pd-trigger — Design Document

ai-ee v1 pipeline

Board review (P8 adversarial) - pd-trigger

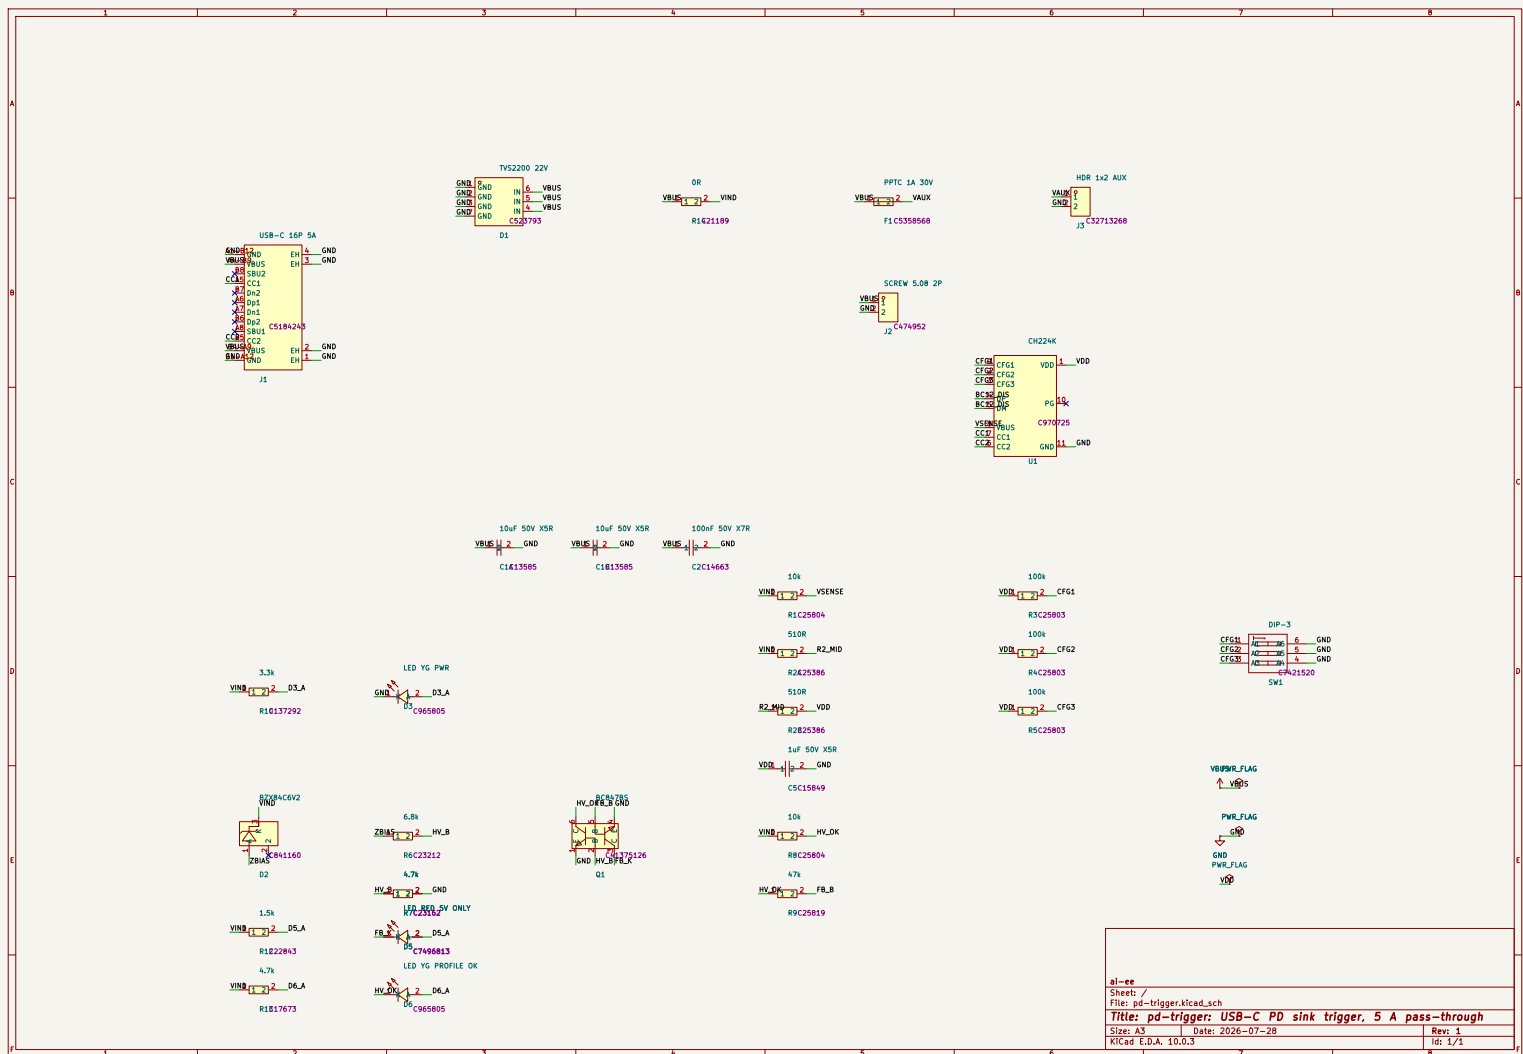
W1 dp-dm-short-at-chip: architecture’s PD-only short (`/BC12.DIS`) ACCEPTED by the reviewer as hardware-SAFER than the datasheet’s connector wiring (removes a 21V-onto-3.8V-abs-max fault path). Cost: no QC/BC legacy support - the board is “PD sources only”; goes on B.SilkS + order docs. W2 vdd-worst-corner: true worst case 0.979mA at 4.4V low-line all-straps- closed vs unpublished CH224K IDD - bounded by WCH’s own reference circuit; V1 bring-up step: measure VDD at the 5V profile; contingency = both 510R -> smaller (documented floor 600R total). Bring-up addenda: buzz out Q1 E/B/C once (clone PDF JS-gated; Nexperia- standard pinning verified as the compatibility claim).

reports/render_final/top.png

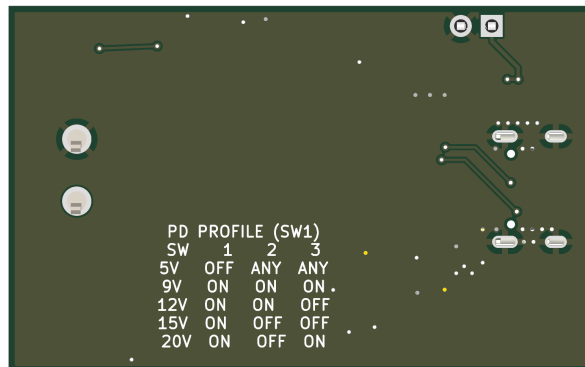
E1 - 5 A return chokes at J1's GND contact pads (error, checker-blind by design D7)

The 4 GND cable contacts land on two merged SMD pads (F.Cu only): A1-B12 at (17.63,39.31) and B1-A12 at (17.63,45.71), nominally 2.5 A each at the 5 A rating. Their ONLY copper into the B.Cu return pour:

- A1-B12 (top): a 0.2 mm wide, 2.7 mm long F.Cu chain (3 segments) into shell pad 1's THT barrel, plus one 0.6/0.3 via whose annulus grazes the pad corner by ~0.05 mm (etch-tolerance-level). 0.2 mm at 2 oz = 0.80 A capacity at 10 C rise (pipeline model); at 2.5 A the same model gives ~133 C rise (short-neck heatsinking will moderate this, but it is a >3x overcurrent on the model's own terms). ~13.6 squares = 3.3 mohm.
- B1-A12 (bottom): a 0.2 mm x 1.3 mm trace into ONE 0.6/0.3 via. The board's own via budget (constraints via_amps 0.5) says 2.5 A needs 5 vias; there is 1. Shell pad 4 sits 0.32 mm away but is NOT connected on F.Cu - its copper does not help.

Architecture D7/power_tree structural requirement ">= 10 vias at J1's GND pads" (the stated substitute for keeping GND out of power[] so check_current stays quiet): not delivered. DRC cannot see it (0.2 mm is netclass-legal), check_current cannot see it (GND undeclared), check_return_path no-ops (no high-speed key). Failure mode: sustained 5 A at any profile heats the two necks far past the 10 C design intent; long-term trace/joint fatigue, intermittent ground, and full return current cascading onto the surviving 0.2 mm chain. Fix is cheap at P9: an F.Cu GND spandrel bonding each contact pad to its shell pad (the VBUS pour top edge is at y 39.7 - the strip above it, and the strip x < 17.2 plus the region south of y 46, are free) plus 4-5 vias per side.

E2 - Safety/waiver silk markings absent (error, promised artifact) Board-wide gr.text count is ZERO; B.SilkS carries nothing at all (both B.SilkS references in the file are the stackup layer table). Missing, each one a written promise:

- AUX 1A MAX + V+/GND at J3 (P0 answer 4 "silk-marked", V10). F1 makes overload safe-by-hardware, but polarity of the 2-pin aux header is unmarked.
- PD SOURCES ONLY (ERC waiver W1's standing condition: "goes on B.SilkS + order docs"). The waiver's silk half is currently unfulfilled.
- J2 screw-terminal polarity. Trunk lands on J2 pad 1 = the LOWER screw (board-bottom side); nothing anywhere tells the bench user which screw is V+. Reverse-wiring a load on a 100 W output is the single easiest field mistake this board can cause.

E3 - User-interface silk absent (error, promised artifact)

- The five-row profile table on B.SilkS - D3 calls silk "the user interface" and specifies the table verbatim; the bottom is a clean pour with room. Without it the ON/OFF-to-voltage map exists only off-board; a user WILL set 9 V expecting 12 V by trial and error. (Fail-safe floor: any wrong guess >= the 5 V fallback, and OFF-fail = 5 V - the mistake is bounded but real.)

- LED legends PWR / 5V ONLY / PROFILE OK (D4/V10): the render shows refdes D3/D5/D6 only. The entire P0-answer-6 "visible fallback indication" scheme is mute without the words - a lit red LED labeled "D5" indicates nothing.

- Cable disclaimer "20V @ 5A needs a 5A e-marked cable and a 100W source" (V10 lists it as silk; power_tree s7 allows documentation - at minimum it must reach the order docs at P9/P10, which do not exist yet; fab/ is empty).

W1 - J1 mouth recessed ~0.4-0.5 mm behind the board edge (warning, flagged at P6) Courtyard/silk front edge $x = 10.18$ vs board edge $x = 9.8$. USB-C receptacles are normally flush-to-overhanging; a recessed mouth lets thick/molded plug overmolds butt the board edge and hold the plug fractionally short of latch - intermittent CC, no PD, "works with some cables". On a bare bench board with arbitrary cables this is a real annoyance risk. Fix: nudge J1 -x 0.5-1.0 mm at P9 (pour edge follows; nothing else in that corridor), or accept and note in order docs.

W2 - Outline 48 x 30 mm exceeds the architecture's hard ceiling (warning, drift) Edge.Cuts = (9.8,27.51)-(57.8,57.51) = 48 x 30 mm. D9: nominal 45 x 25, "hard ceiling 48 x 28 mm"; 30 mm violates D9's own ceiling by 2 mm even though it equals P0 answer 5's literal +20 % (40x25 -> 48x30, +44 % area vs the brief's target). No digest discloses the growth past D9. Consequence is cost/footprint only, but it must be disclosed to the user at the checkpoint rather than discovered.

A1 - J2 GND pad ties to the return pour through 4 thermal spokes (advisory) J2 pad 2 (THT, 2.4 mm pad / 1.6 mm drill) connects via 4 x 0.5 mm diagonal spokes = 2.0 mm total at 2 oz -> model 8 C rise at 5 A. Legal and functional, but these are the most-loaded copper necks on the whole return after E1, at a hand-soldered joint. Recommend a solid-connect override (or a short fat GND strap) at P9; zero cost. (Verified all 4 spokes present; the VBUS pad 1 island below it is barrel-tied, normal.)

A2 - F1's VBUS feed branch is 18.3 mm long (advisory, V8 letter-violation) V8/D8 wanted all five VBUS taps hugging the run with 2-3 mm stubs. D1, C1A, C1B, C2, R14 comply; F1's feed runs 8.4 + 6.5 + 3.4 mm at 1.75 mm width to the top-left corner. Width-compliant (V8's actual purpose), carries ≤ 1 A in service; only cost is ~30 mm² of extra always-live 20 V copper. No action needed; recorded as drift.

A3 - Floating 0.65 mm² GND sliver at (20.0, 28.5) (advisory, cleanup) plane_repair's own dead-island fact (0 anchors), between J3/SW1 clearances. Cosmetic / minor DFM nit; remove at P9 cleanup or accept.

A4 - /VAUX at PPTC max-non-trip current (advisory) /VAUX routes at 0.3 mm (required 0.25 at the declared 1.0 A -> 7 C). F1's worst sustained NON-trip current is ~1.8 A -> model 27 C rise on those runs until/unless the PPTC trips. Bounded, no damage threshold approached (70-80 C copper on a 20 V node); acceptable. Recorded so nobody "fixes" it blind later.

```
# P8 digest (pd-trigger)
verify PASS 8/8 first try. Fable reviewer: 4 err + 2 warn. Copper errors
REAL: 5A RETURN choked at J1 GND pads (0.2mm necks/0.80A, 1 via) - rebuilt
w/ priority-1 F.Cu GND lobes (connect.pads solid) + 15 new 0.6/0.3 vias ->
5.68A/4.70A per pad, 16 vias (D7 >=10 met). Removed 2 stitch vias 0.121mm
from THT drills - LIVE-PROVEN KiCad DRC blind spot (via-drill vs same-net
pad-drill never checked, finding 34). Silk errors: 17 texts added; agent
CORRECTED the orchestrator's B-table spec (raw CFG bits would be inverted
vs ON=GND switch reality - printed switch positions). Warns: mouth recess
-> order docs; outline 48x30 deviation recorded; C1B channels waived w/
numbers. Re-gates: drc_routed 0/0, verify 8/8. H4 AUTO-approved.
```
